S E R V I C E N O T E

70620B Preamplifier**Serial Numbers:** 0000A00000 / 2951A00220**Exceptions:** 2951A00195, 2951A00197, 2951A00198, 2951A00199, 2951A00202,
2951A00202 to 2951A00220**Eliminate residual responses caused by a noisy power supply****To Be Performed By:** Agilent-Qualified Personnel**Parts Required:**

DATE: 01 November 1992

Figure 1. A2 Power Supply/Controller Board

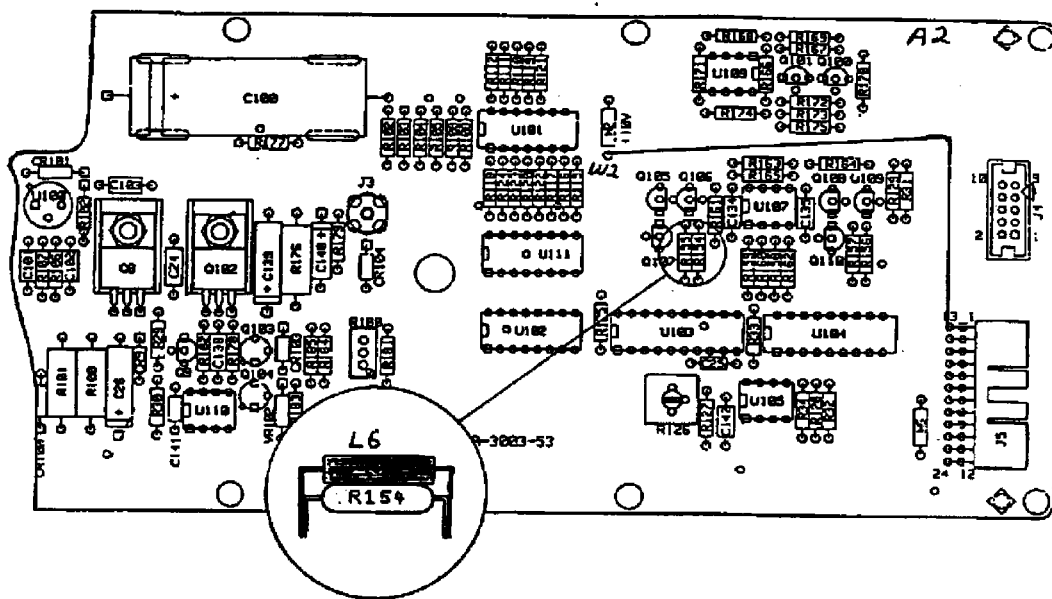
Residual responses are occurring in the 1.5 to 3.5 MHz range in systems using the 70620B Option 001 or the 70621A Preamplifiers. The responses are caused by digital signals that are present on the A2 Power Supply/Controller Board which are conducted onto the +5V supply and also onto A4 Hi/Lo Band switch control line. The +5V supply is shared by the A7 RF amplifier microcircuit which is highly sensitive to a contaminated supply.

The biasing for the RF amplifier is changed from the +5V to a +6V supply which is isolated from the digital signals. An inductor is also added in series with the switch control line to work with the feedthru capacitor in the switch to create a low pass filter. R154 is in parallel with L6 to limit the Q of the filter to 2.

1. Jumper A2W2 with 26 ga. wire to A2J5 pin 13. See Fig 1.
2. Secure the wire to the A2 board with Hardman Adhesive.
3. Remove the original A2R154 and replace it with a 121 ohm resistor.
4. Load A2L6 "piggy back" onto A2R154 and solder into place. See Fig 1.
5. Remove original W5 wiring harness assembly and replace with the 70620-60116 for the 70620B or 70621-60007 for the 70621A.
